Subject: Findings of Fact, Conclusions, and Order for Violation #21173 Fossil Rock Resources, LLC, Fossil Rock Mine, C/015/0009

**IN THE MATTER OF THE
INFORMAL ASSESSMENT
CONFERENCE for PROPOSED
ASSESSMENT; VIOLATION No.
N21173, FOSSIL ROCK
RESOURCES, LLC, FOSSIL
ROCK MINE, C/015/0009, EMERY
COUNTY, UTAH**

**FINDINGS of FACT,
CONCLUSIONS OF LAW
AND ORDER**

RE: Fossil Rock Resources, LLC Permit #C0150009, Waste Rock Site Ditch Evaluation and Request to Terminate NOV #21173

Photo 3: Equipment Access in Background

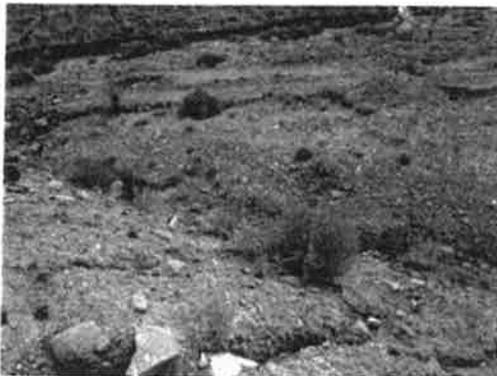
2. The NOV states that, "ditch DB is not-existent... and an access road has been constructed in its place." During our site visit we found the ditch is indeed in place though there is evidence of previous equipment access in the area and the access area had been roughened, see Photo 3. Two cross sections of ditch DB were measured where the ditch is the smallest. The actual flow capacities are

Photo 4: Ditch DB Cross Sections

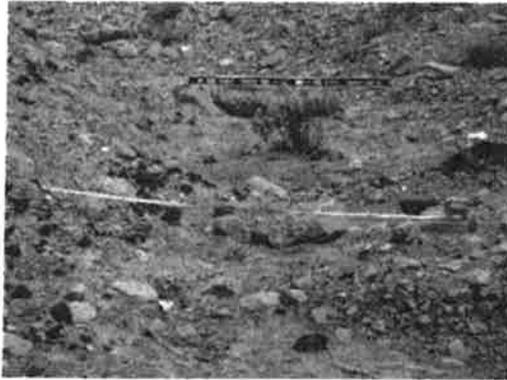
After a review of the permit documents, specifically Appendix C, the design flow for ditch DB was designed based on a watershed of 3.4 acres. FRR is not currently aware why the original design watershed was so large. The actual watershed is 1.1 acres in size. This is likely the reason why there is no evidence that ditch DB has undergone the permitted design flows. The two watershed boundaries are shown in the attached drawing. See Photos 4 and 5 for pictures of the two cross sections measured.

Figure 8: Ditch Section View

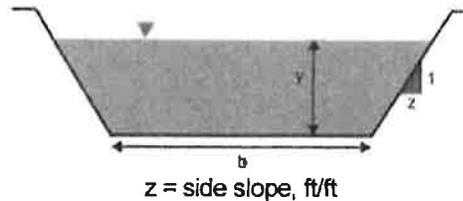
For a trapezoidal shaped open channel as shown in Figure 8, the area, hydraulic radius and wetted perimeter are calculated as follows. See the figure 8 below.

The original design required the mean velocity to be a maximum of 5 feet per second in order to reduce the potential for erosion. The original design used a Manning's coefficient of 0.035 and channel slopes of 2% and 12% for ditches DA and DB, listed respectively.
